# ERRATA AND RESPONSE TO PUBLIC COMMENTS

## SOUTH ENTRANCE FEE STATION RECONFIGURATION

### ENVIRONMENTAL ASSESSMENT

ZION NATIONAL PARK  
SEPTEMBER 2018

Figure 3. Current

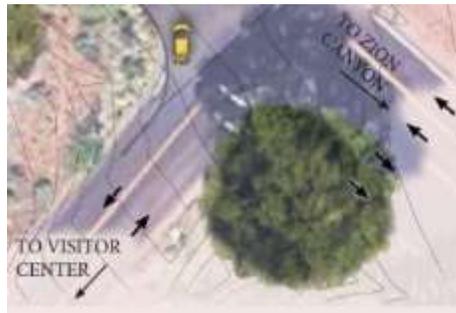
C) Alternatives Carried Forward: Figure 3. Alternative B – South Entrance Fee Station Reconfiguration (Pg. 8): Revise figure.

Figure 3 illustrates four (4) traffic lanes extending beyond the intersection leading to the Visitor Center, two (2) entering the park (northbound) and two (2) exiting the park (southbound).

2. Commenter expresses concern over the traffic flow arrows illustrated in Figure 3. Alternative B South Entrance Fee Station Reconfiguration and recommends the arrows designate appropriate turning lanes.

Figure 3 illustrates three (3) traffic lanes extending beyond the intersection leading to the Visitor Center, one (1) entering the park (northbound) and two (2) exiting the park (southbound). The middle lane will serve as a left hand turn lane for vehicles traveling to the Visitor Center before exiting the park.

2. The pavement arrows on the proposed design have been corrected to illustrate the existing traffic flow pattern. Existing conditions will not be altered during this project. Refer to the **C. Alternatives Carried Forward Figure 3** in the Errata above for additional details.
